Steven Sands, M.S.
Iso-Diagnostic Services
of Michigan
575 Robbins Drive
Troy, Michigan 48083

William Adam, Ph.D.
Materials Licensing Section
United States Nuclear Regulatory Commission
Region III
799 Roosevelt Road
Glen Ellyn, Illinois 60137

In response to your letter dated June 17, 1985 (Control No. 78733), we are providing the additional information that you requested in order for the submitted nuclear pharmacy application to become approved.

Figure 1. Dose preparation area, indicating shielding.

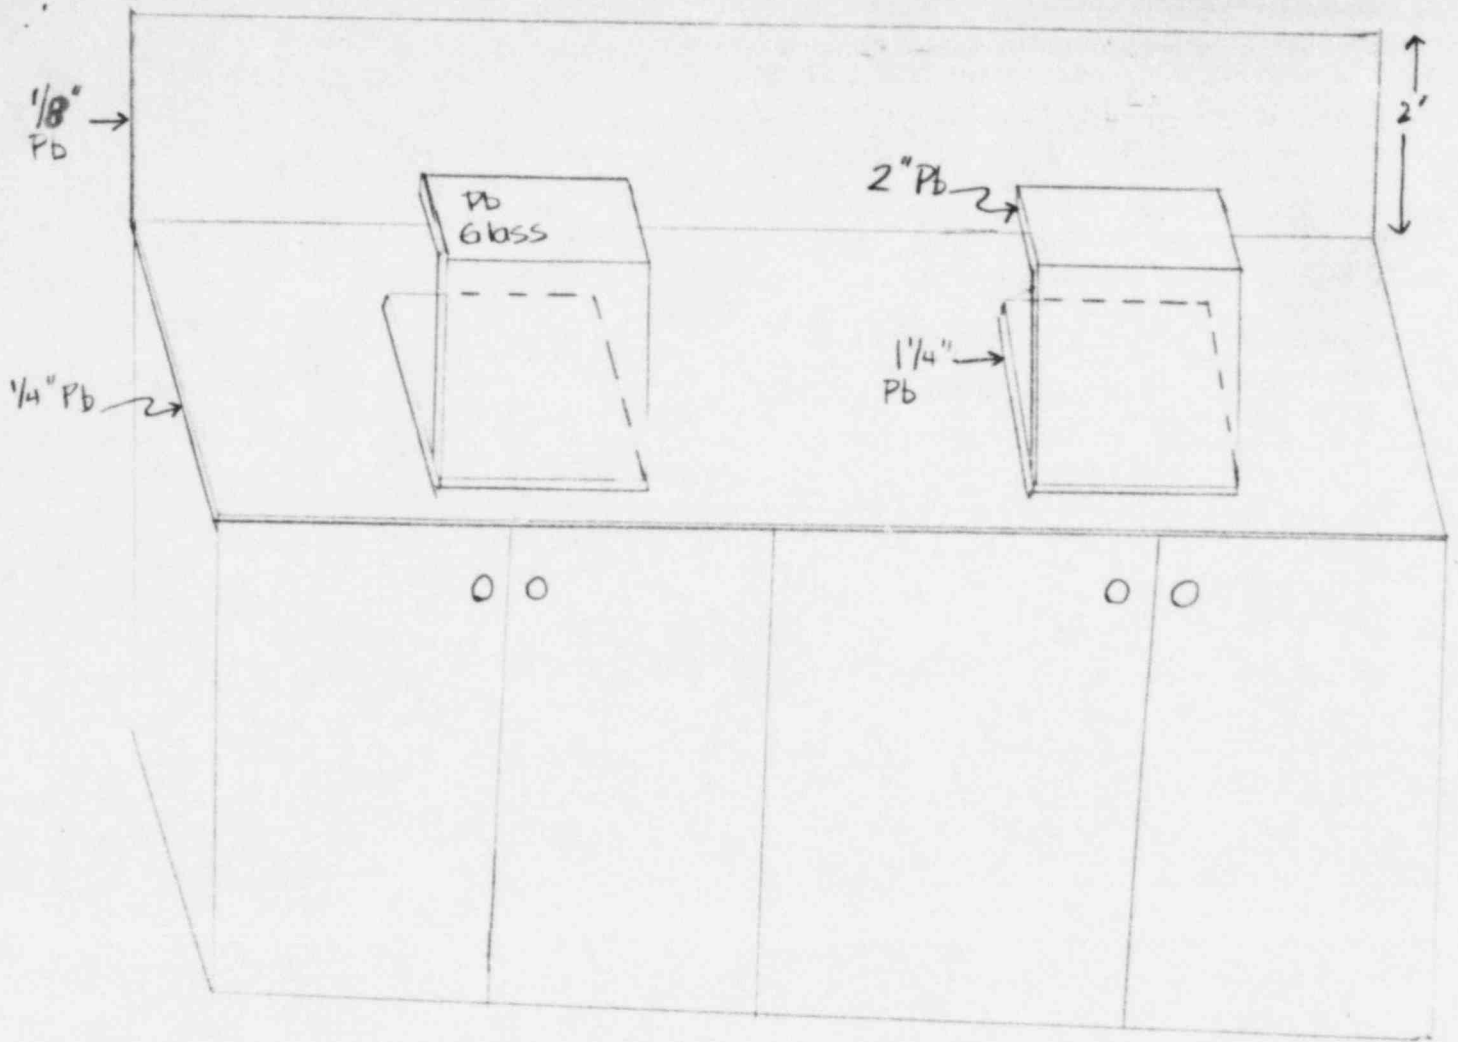
1. a) The shielding available in the compounding and dose preparation areas consists of two lead L-blocks of 1 1/4" horizontal thickness and 2" vertically. Each L-block contains a leaded glass portion for convenient, yet protected, viewing of the work area. One L-block is placed at each of two work stations. Note that, in Item 9, page 16, of our license application, the counters upon which the L-blocks will be located are constructed of 1/4" lead. Also, the adjacent wall will contain at least 1/8" of lead extending 24 inches upward from the countertop level. See attached Figure 1.

Figure 2. "Drop-off area" for deliveries during off-hours. The shielded lead box for placement of packages is shown.

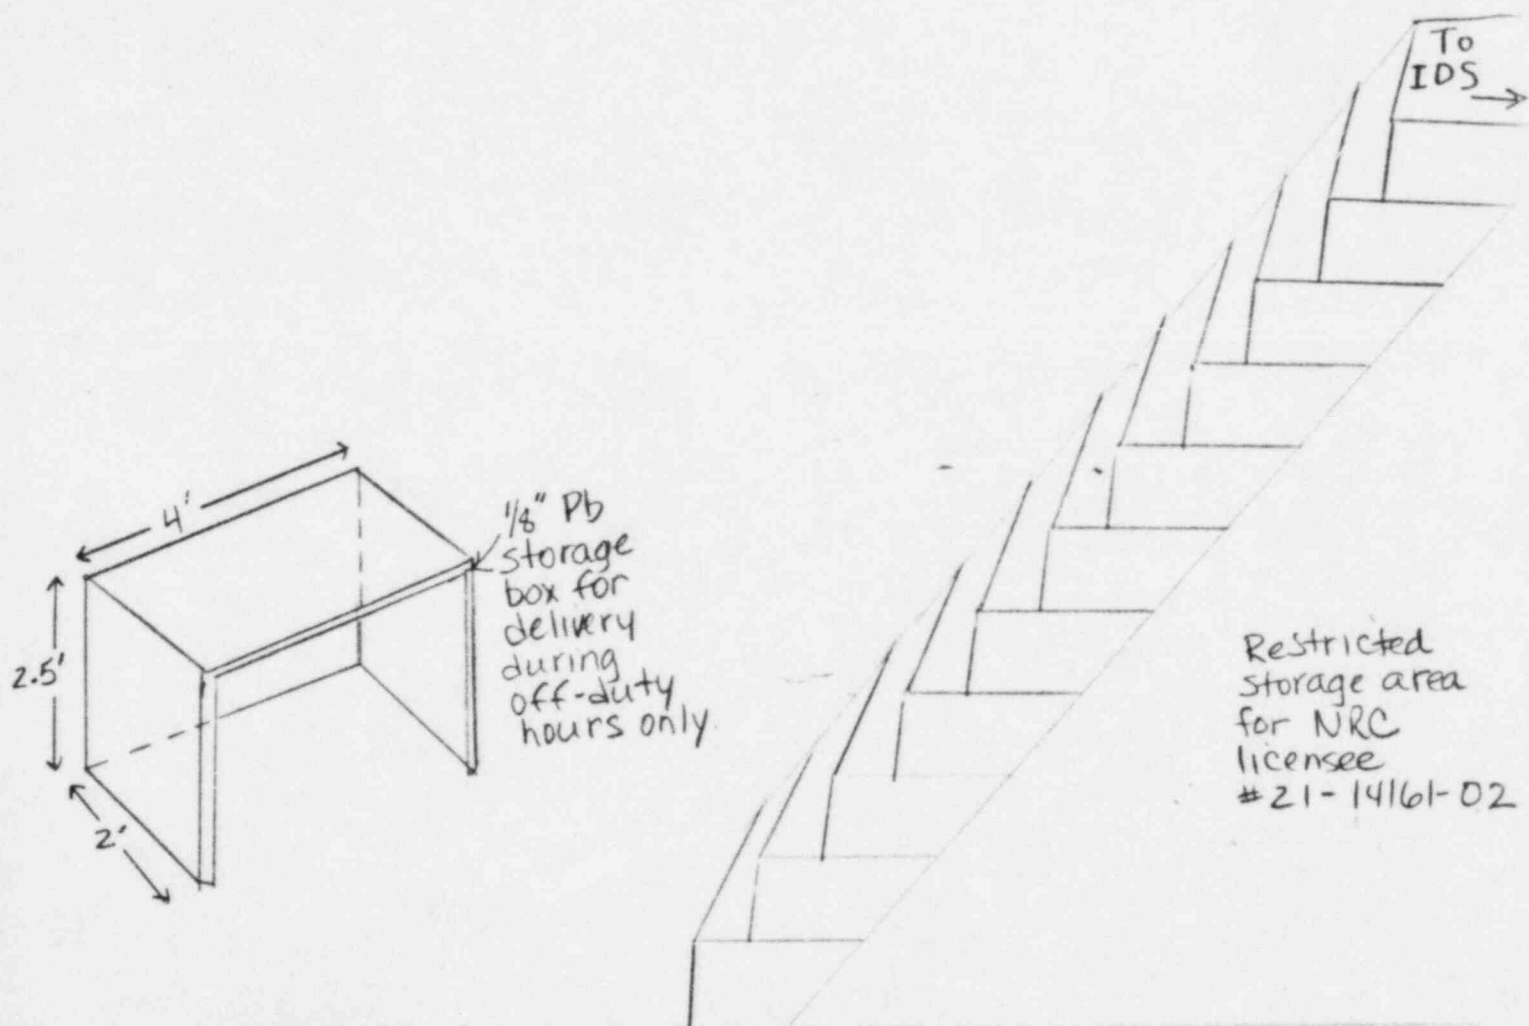
- b) The "drop-off" area will contain a lead box of thickness 1/8" and dimensions 4.0' x 2.0' x 2.5'. The box, as shown in Figure 2, attached, will have four walls (i.e. three vertical sides and a horizontal top). The two walls which are left open are (1) the bottom, which rests on the concrete foundation of the building, and (2) the front face of the box, for insertion of packages. At all times, the box will be placed such that the open face is directed toward the staircase on the ground level. The area potentially exposed at the face of the box behind the staircase is a restricted area, currently used for storage of low-level waste by NRC licensee #21-14161-02.
